Access Compliance Report

Public Rights-of-Way

Intersection ID: 48949	Main Street: OLD_STONE_CROSSING_DR	Cross Street: DAVID_JENNINGS_AV	Location: E
ADA ID: 21FEBCEBDE1	Ramp Type: PerpDiag	Initial Pass/Fail: Fail	Overall Compliance: No
Severity Score: 8.75			
Codes/Mitigation Info/Possible Solution		Field Measurements/Component Compliance

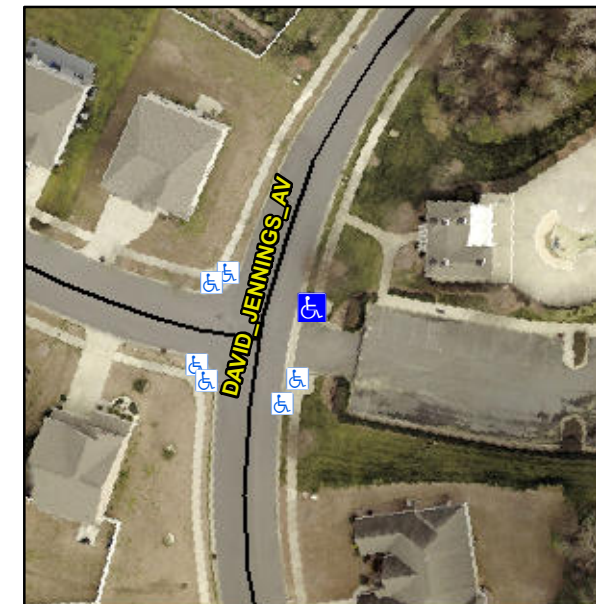
Not Found, R304.5.1

Compliance	Description	Data	Compliance	Description	Data
N/A	Ramp Length (in)	47.5	Yes	Ramp Slope (%)	6.1
No	Ramp Width (in)	47.5	Yes	Ramp XSlope (%)	1.2
N/A	Flare Type LT	N/A	N/A	Flare Type RT	N/A
N/A	Flare Slope LT (%)	N/A	N/A	Flare Slope RT (%)	N/A
N/A	Flare Traversable LT?	N/A	N/A	Flare Traversable RT?	N/A
N/A	Landing Length (in)	N/A	N/A	DWS Provided?	N/A
N/A	Landing Width (in)	N/A	N/A	DWS Contrast?	N/A
N/A	Landing Slope (%)	N/A	N/A	DWS Length (in)	N/A
N/A	Landing X Slope (%)	N/A	N/A	DWS Full Width?	N/A
N/A	Landing Curb? (Y/N)	N/A	N/A	DWS Offset (in)	N/A
N/A	Shared Landing?	N/A			
N/A	Gutter Ponding?	N/A	N/A	Gutter Slope (%)	N/A
N/A	Gutter Lip Ht (in)	1.0	N/A	Gutter X Slope (%)	N/A
N/A	Painted X Walk1?	No	N/A	Painted X Walk2?	No
	X Walk 1 Direction	To NW		X Walk 2 Direction	To S
N/A	X Walk 1 Width (in)	N/A	N/A	X Walk 2 Width (in)	N/A
	X Walk 1 Slope (%)	1.4		X Walk 2 Slope (%)	1.4
	X Walk 1 X Slope (%)	3.3		X Walk 2 X Slope (%)	3.6

Remove & Replace Curb Ramp With Two New Directional Ramps or Equivalent.
